SUBJECT: BROWNS FERRY NUCLEAR PLANT, UNITS 1, 2, AND 3; SEQUOYAH NUCLEAR PLANT, UNITS 1 AND 2; WATTS BAR NUCLEAR PLANT, UNITS 1 AND 2 – ISSUANCE OF AMENDMENT NOS. 309, 332, 292, 345, 339, 128, AND 31 REGARDING UNBALANCED VOLTAGE PROTECTION (EPID L-2017-LLA-0391)

SAFETY EVALUATION BY THE OFFICE OF NUCLEAR REACTOR REGULATION  
AMENDMENT NO. 309 TO RENEWED FACILITY OPERATING LICENSE NO. DPR-33  
AMENDMENT NO. 332 TO RENEWED FACILITY OPERATING LICENSE NO. DPR-52  
AMENDMENT NO. 292 TO RENEWED FACILITY OPERATING LICENSE NO. DPR-68  
AMENDMENT NO. 345 TO RENEWED FACILITY OPERATING LICENSE NO. DPR-77  
AMENDMENT NO. 339 TO RENEWED FACILITY OPERATING LICENSE NO. DPR-79  
AMENDMENT NO. 128 TO FACILITY OPERATING LICENSE NO. NPF-90  
AMENDMENT NO. 31 TO FACILITY OPERATING LICENSE NO. NPF-96  
BROWNS FERRY NUCLEAR PLANT, UNITS 1, 2, AND 3  
SEQUOYAH NUCLEAR PLANT, UNITS 1 AND 2  
WATTS BAR NUCLEAR PLANT, UNITS 1 AND 2  
DOCKET NOS. 50-259, 50-260, 50-296, 50-327, 50-328, 50-390, AND 50-391  
TENNESSEE VALLEY AUTHORITY

Figure 3.3-1: Figure 14.1 of the NEMA-MG1

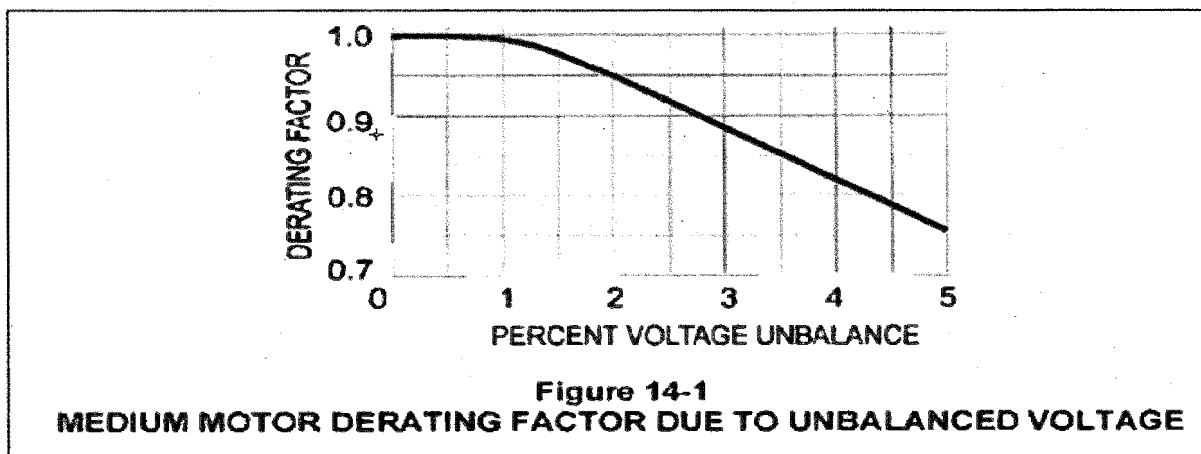
In Figure 14.1, "Medium Motor Derating Factor Due to Unbalanced Voltage," of NEMA MG-1, the derating curve shows when voltages are unbalanced, the rated horsepower of the motor should be multiplied by the factor to reduce the possibility of damage to the motor, as shown in Figure 3.3-1 below.

NEMA MG-1 states, in part, that, "Operation of the motor above a 5-percent unbalance voltage condition is not recommended."

Not detectable is less than ( $<$ ) 1.2 V (1 percent of 120V): Figure 14-1 of NEMA MG-1, as shown above, the derating factor of 0 percent to 1 percent unbalanced voltage is 1 (i.e., no derating applies for up to 1 percent unbalanced voltage). Therefore, the motor can withstand 1 percent (1.2 V) of the unbalanced voltage and the error in the ABB relay is acceptable.

Figure 3.3-2: TVA UVR Allowable Value and Trip Setpoints Relationships

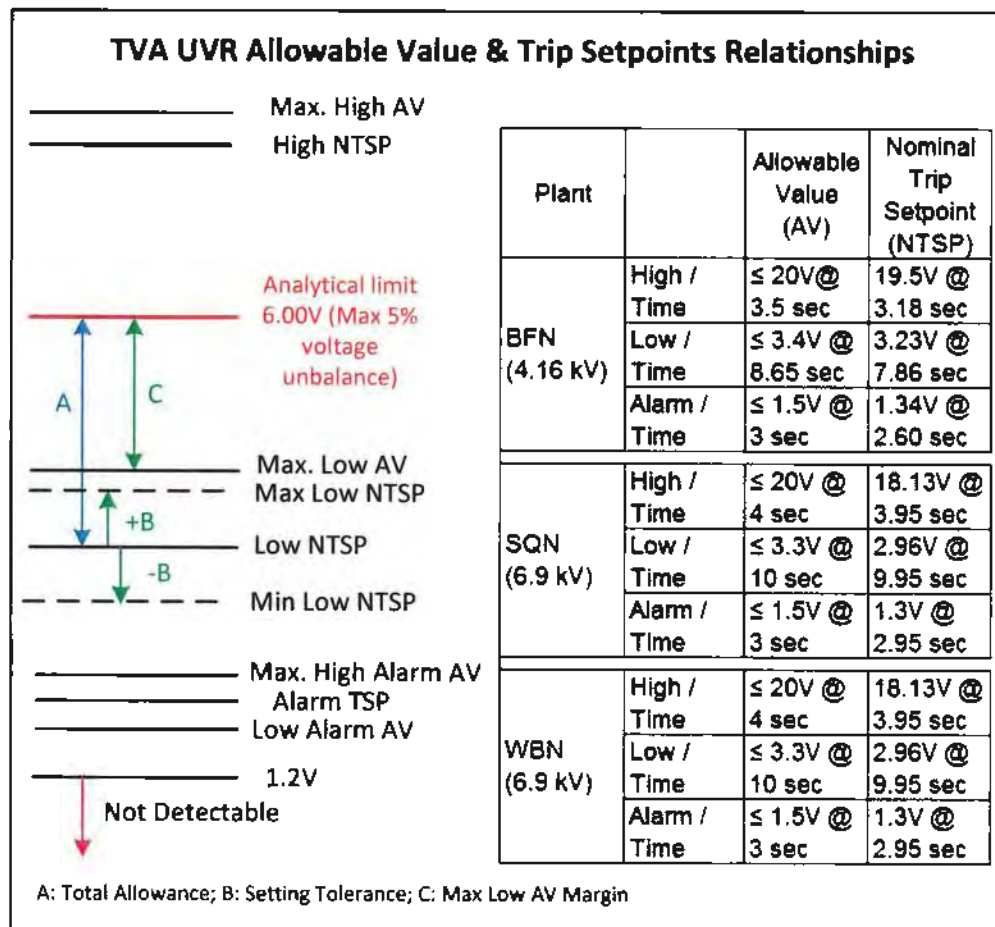
The UVR setpoints should ensure that voltage unbalances higher than 6 V are detected with minimum delay time. The proposed setting of the new UVR is described in Figure 3.2, "TVA UVR Allowable Value and Trip Setpoints Relationships," below. The licensee has proposed maximum short time high unbalance AV of 20 V, which is based on factors such as maximum limit of voltage unbalance to prevent motor stalling and preclude unnecessary bus power source trips. This relay provides a faster tripping time for high-level unbalances to protect against catastrophic load failures.

- Section 4.3.2 of ISA-S67.04 states, "A channel whose trip setpoint as-found condition exceeds the AV should be evaluated for operability, considering the setpoint calculation methodology."
- As shown in Figure 3.3-2, "TVA UVR AV and Trip Setpoints Relationships," below, the upper analytical limit of UVR time delay that is typically only a few seconds (around 3 to 4 seconds) and the lower analytical limit of UVR time delay (equal or less than ( $\leq$ ) 10 seconds) are consistent with the inverse time relationship between unbalanced voltage and motor thermal damage discussed in NEMA MG-1.

As shown in Figure 3.3-2 of this SE, the proposed time delays associated with the AV of 6 V of unbalanced voltage for the new UVRs: (1) are less than or equal 10 seconds, (2) typically vary from 2.6 seconds to 4 seconds at the permissive alarm and high setting levels, and (3) vary from 7.86 seconds to 10 seconds at the low setting level. The time delay for the AVs is longer than the NTSP (of all high, low, or alarm levels).

The NRC staff verified that the time delay settings for the new UVR are consistent with NEMA-MG1. When the proposed UVR is at the high setting level, the time delay settings are within a few seconds ( $\leq 4$  seconds and  $\geq 2.6$  seconds). The low delay time setting minimizes the heating effects that can degrade motor insulation. The time delays associated with the AVs are longer than the time delays of the NTSP (of all high, low, or alarm levels) and are consistent with the analyses of Section A.4 and the relay timing period in Figure A.1 of IEEE Standard 741-1997 (Reference 18). These time delay settings are also consistent with the recommendations of IEEE Standard 3004.8-2016 (Reference 14).

**Figure 3.3-3: NRC Margin Calculation for Browns Ferry**

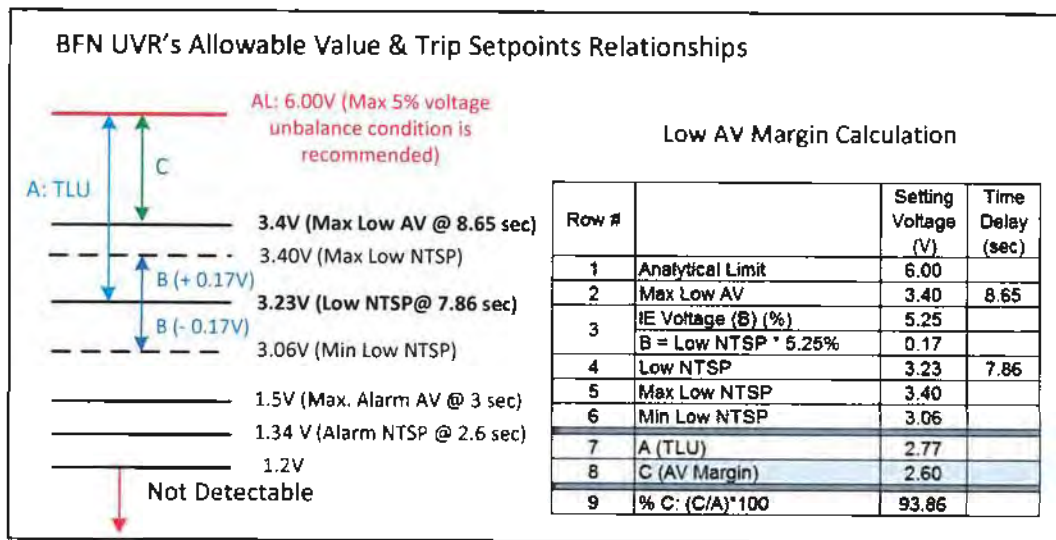
The relationship between the low AV and NTSP of the Browns Ferry UVR is illustrated in Figure 3.3-3, "NRC Margin Calculation for Browns Ferry," below.

The NRC staff used the equations in Section 3.3 of this SE to independently calculate the margins from AL to max AV and max low NTSP. The NRC staff verified that:

- The UVR value of maximum (Max) low NTSP voltage remains less than the max AV voltage.
- The UVR value of minimum (Min) low NTSP voltage is higher than the max alarm AV.
- The margins as indicated (Row 9) in Figure 3.3-3 above are adequate at a value greater than 93 percent to assure that a trip or safety actuation will occur automatically and significantly before the measured process reaches the AL level.

**Figure 3.3-4: NRC Margin Calculation for Sequoyah**

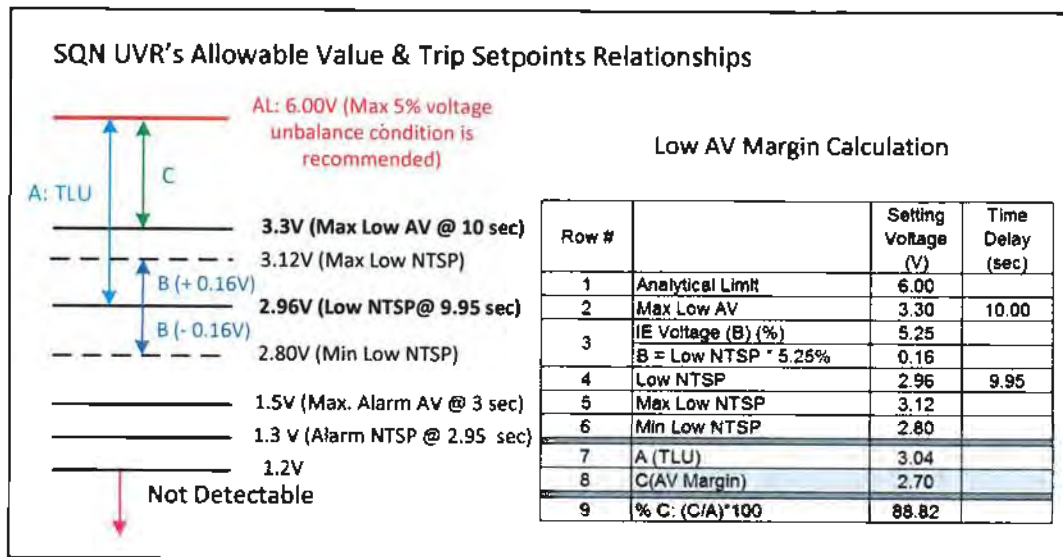
The relationship between the AV and NTSP of the Sequoyah UVR is illustrated in Figure 3.3-4, "NRC Margin Calculation for Sequoyah," below.

The NRC staff used the equations in Section 3.3 of this SE to independently calculate the margins from AL to max AV and max low NTSP. The NRC staff verified that:

- The UVR value of maximum (max) low NTSP voltage remains less than the max AV voltage.
- The UVR value of minimum (min) low NTSP voltage is higher than the max alarm AV.
- The margins (as indicated (row 9) in Figure 3.3-4 above) are adequate at a value greater than 88 percent to assure that a trip or safety actuation will occur automatically and significantly before the measured process reaches the AL level.

Figure 3.3-5: NRC Margin Calculation for Watts Bar

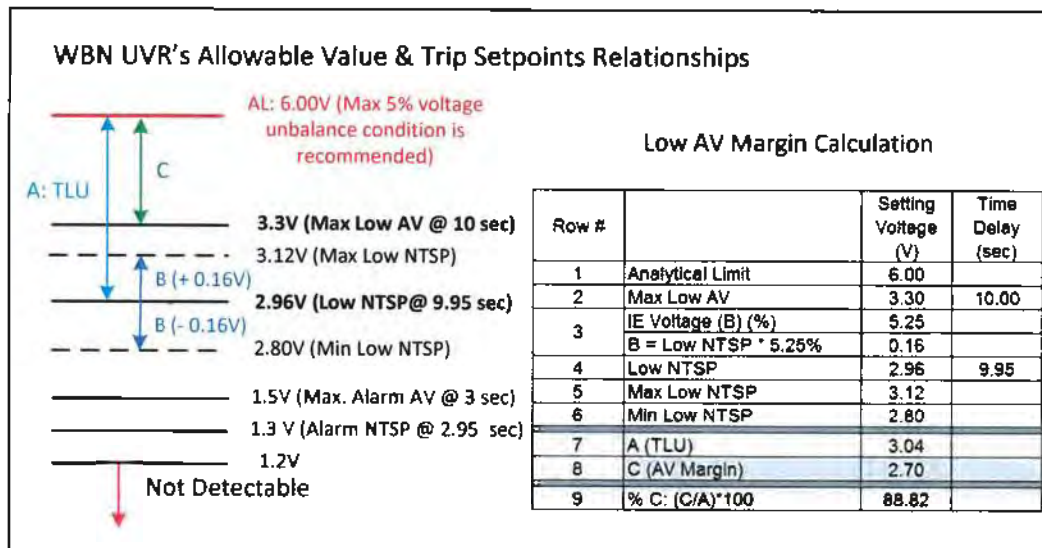
The relationship between the AV and NTSP of the Watts Bar UVR is illustrated in Figure 3.3-5, "NRC Margin Calculation for Watts Bar," below.

The NRC staff used the equations in Section 3.2 of this SE to independently calculate the margins from AL to max AV and max low NTSP. The NRC staff verified that:

- The UVR value of maximum (max) Low NTSP voltage remains less than the max AV voltage.
- The UVR value of minimum (min) low NTSP voltage is higher than the max alarm AV.
- The margins (as indicated (row 9) in Figure 3.3-5 above) are adequate at a value greater than 88 percent to assure that a trip or safety actuation will occur automatically and significantly before the measured process reaches the AL level.
